Burlington Development Review Board

Development Review Board

Wednesday, March 25, 2026, 5:00 PM

To: Development Review Board
From: Mary O'Neil, AICP, Principal Planner
Date: March 25, 2026
RE: ZP-26-54; 49 Henderson Terrace

Project Name!	
CITY, STATE	
PROJECT NUMBER:	HAL49HT
ORIGINATION DATE:	12/21/2025
SCALE:	1/4" = 1'-0"
DRAWN BY:	AAH
CHECKED BY:	AAH
DATE LOG:	Construction 2/14/2026
SHEET CONTENTS:	
EXISTING EXTERIOR ELEVATIONS	
SHEET NO. A200

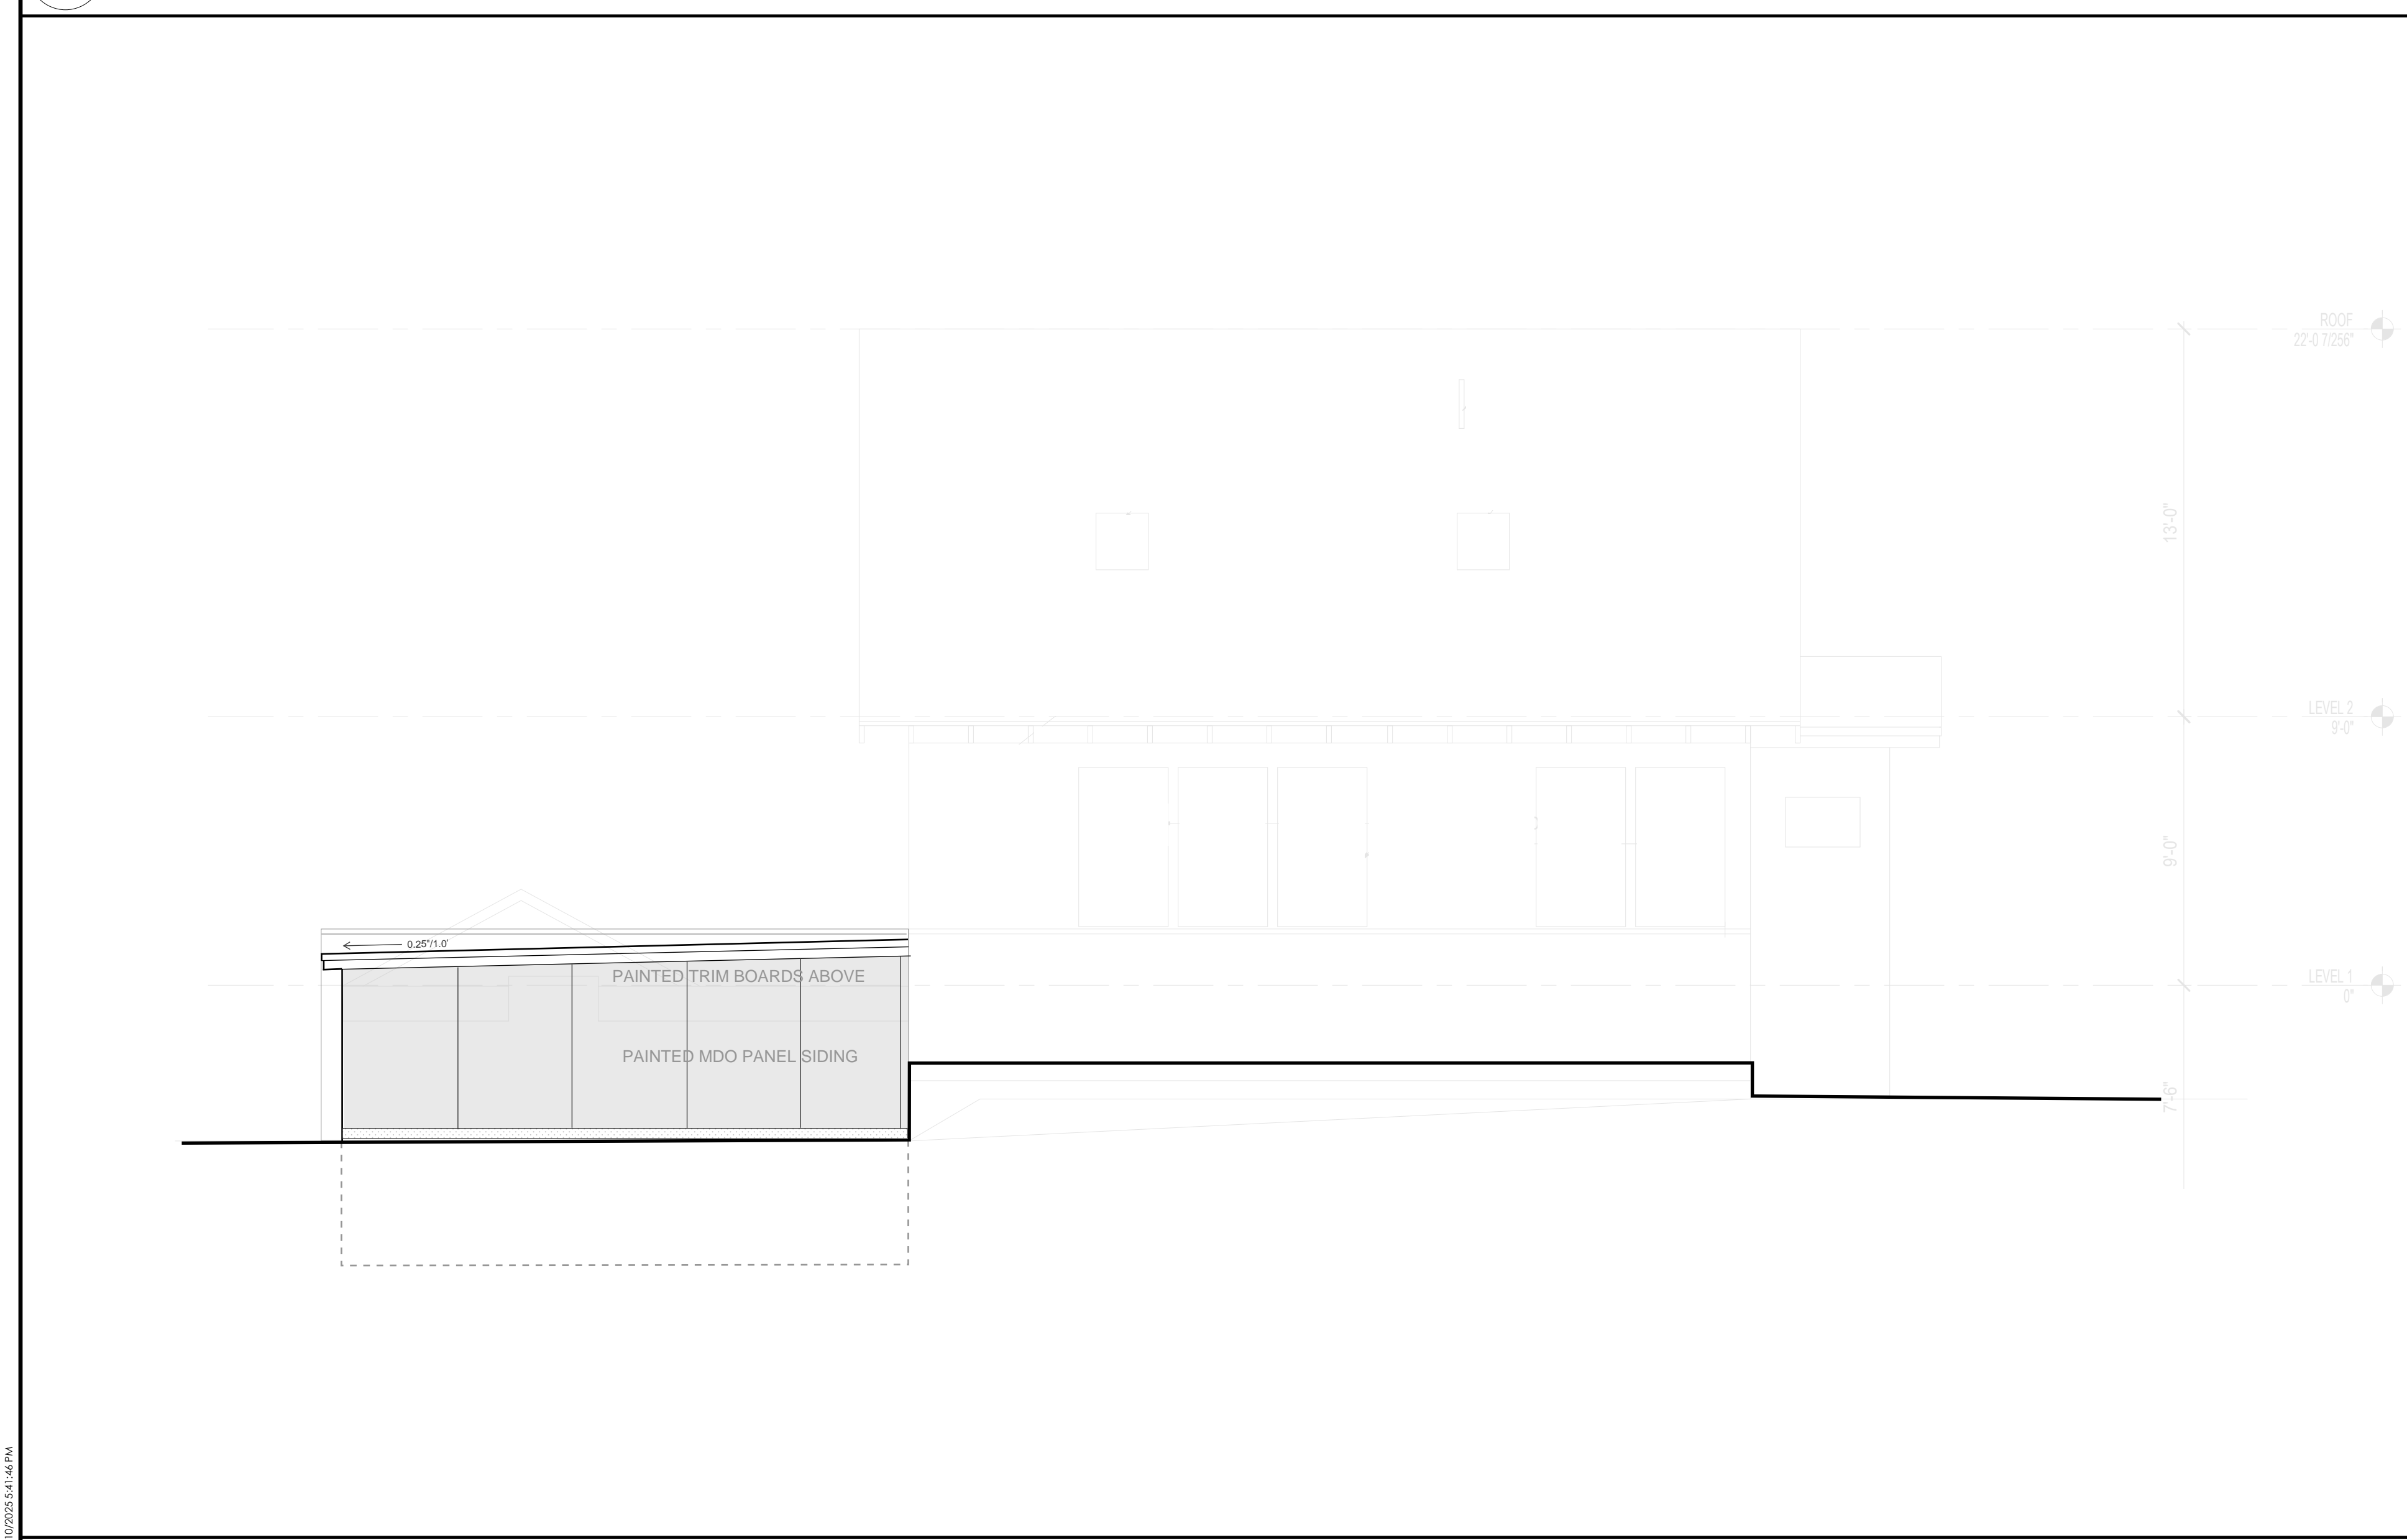
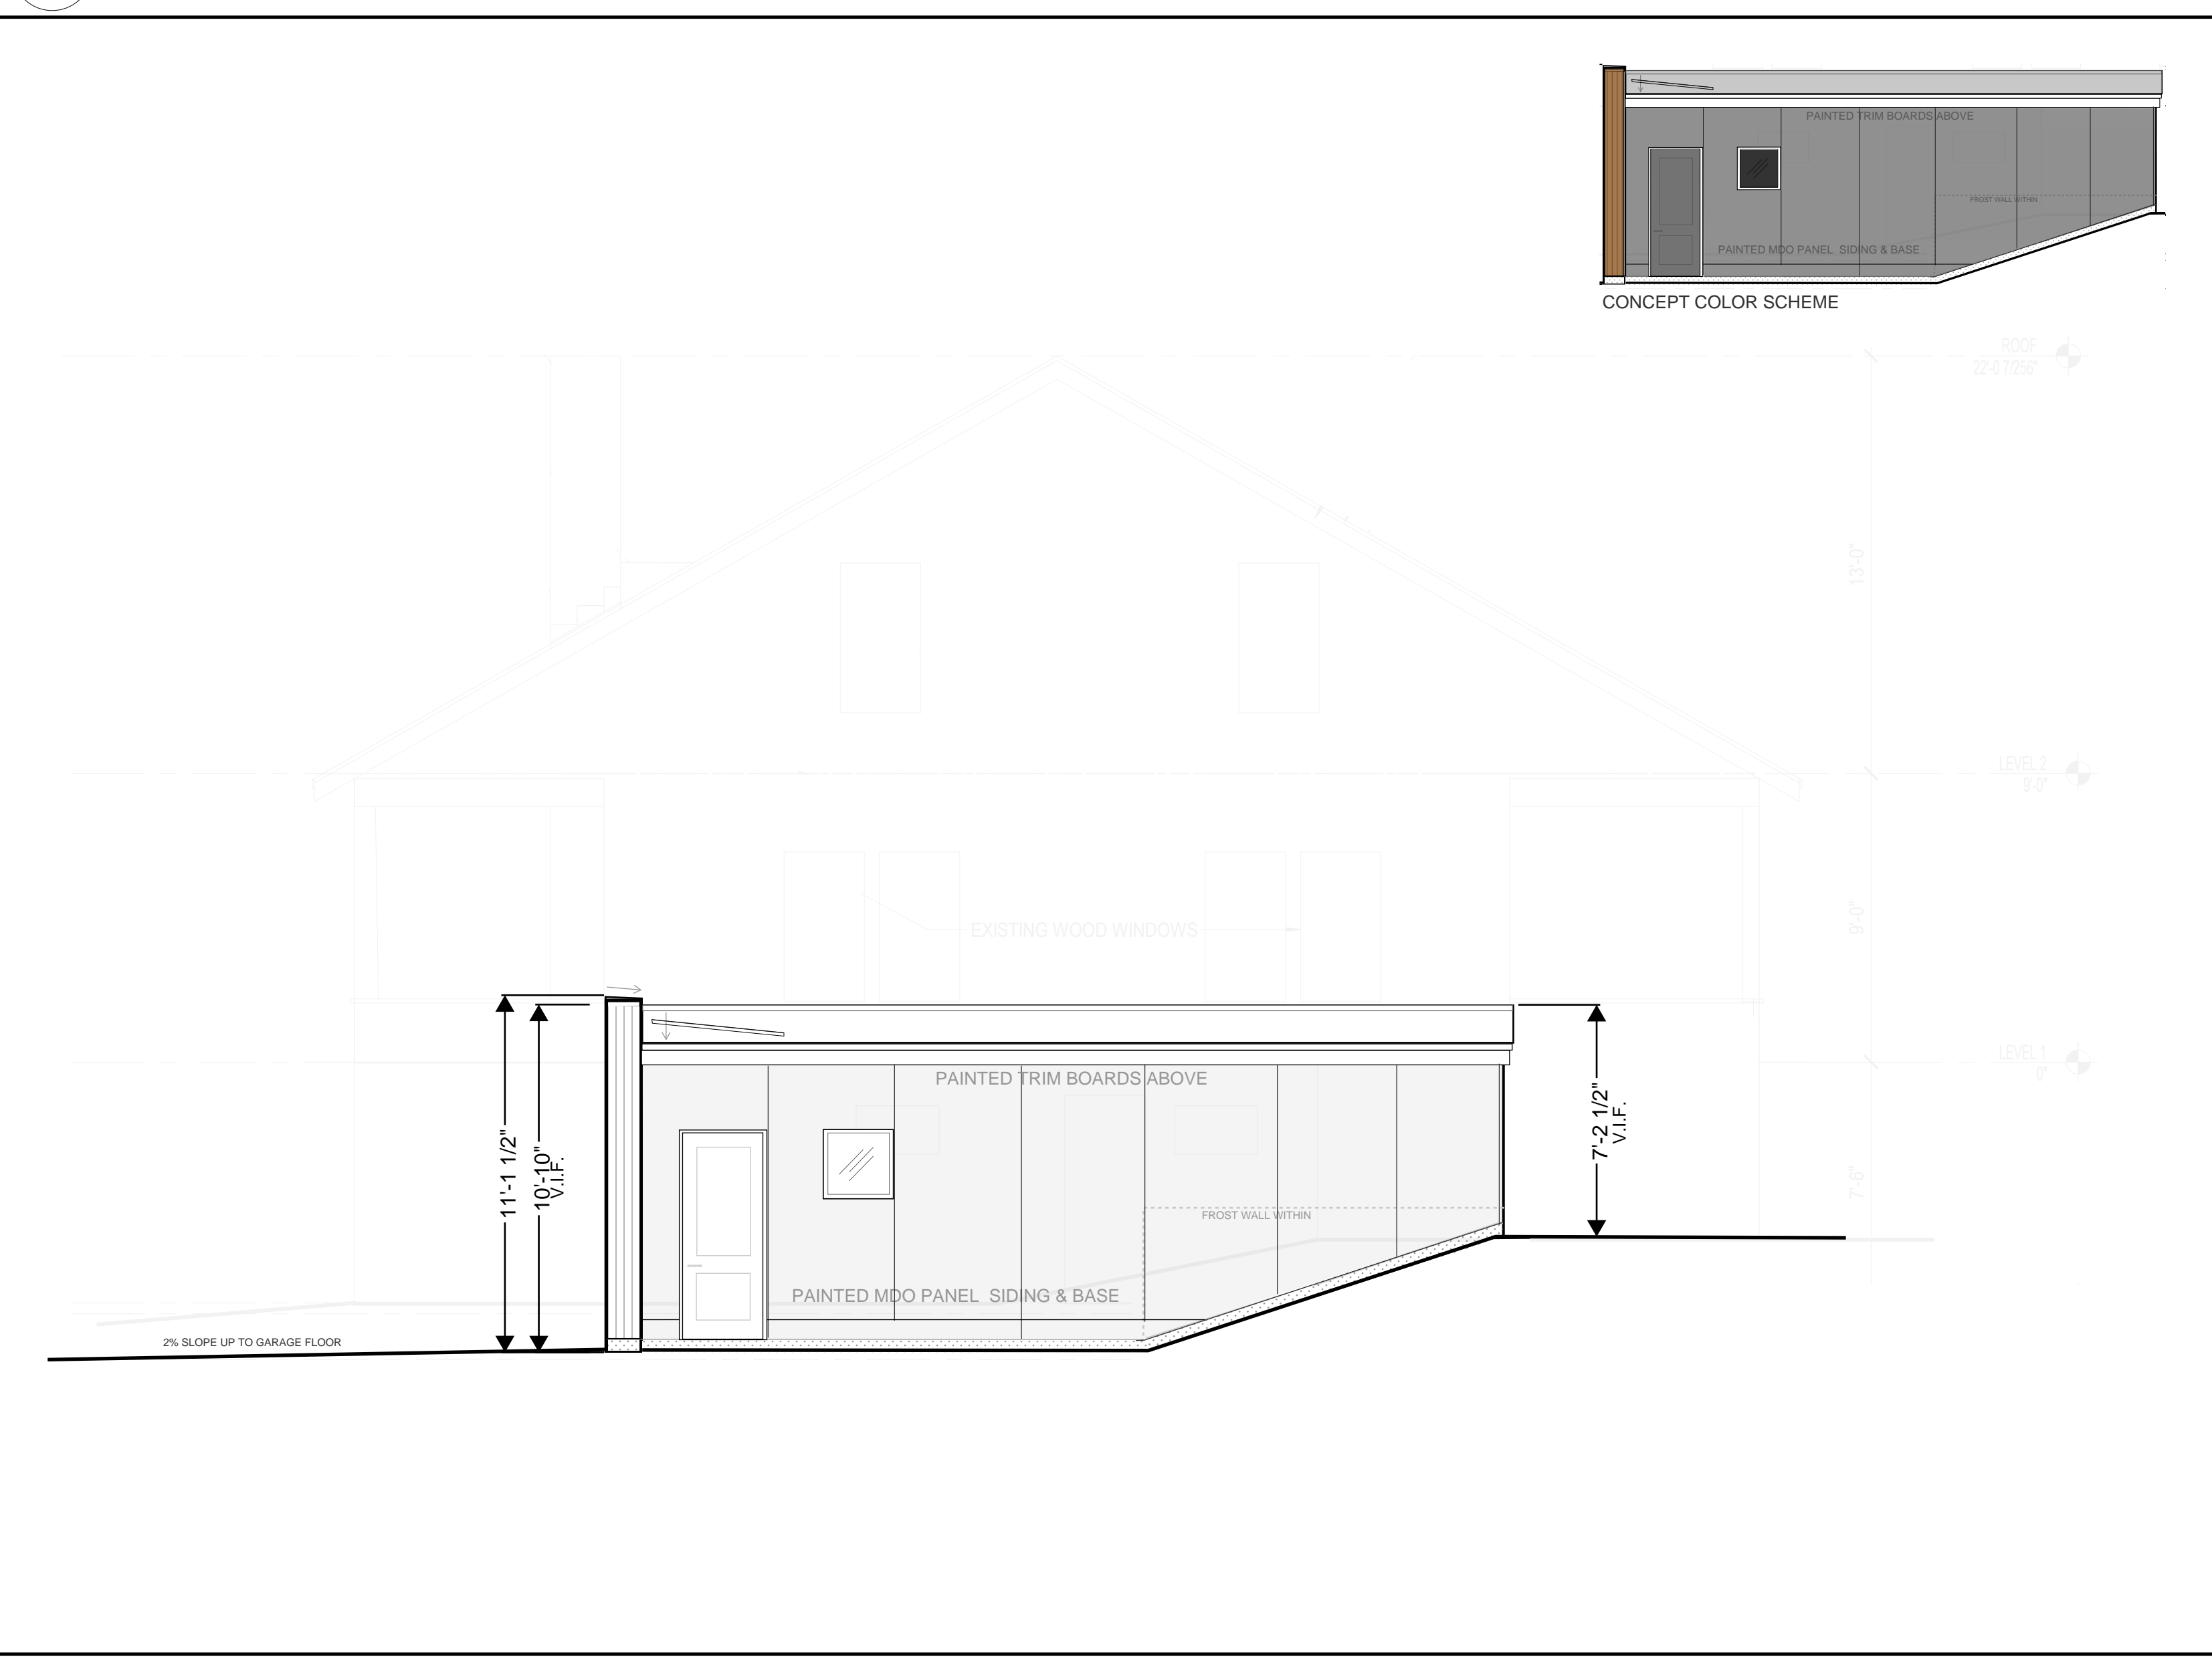
A diverter strip is proposed on the roof above the westerly pedestrian door. See Plans A100 and A200. **Affirmative finding.**

Other than the overhead garage door, there will be a pedestrian door on the west/side of the structure. **Affirmative finding.**
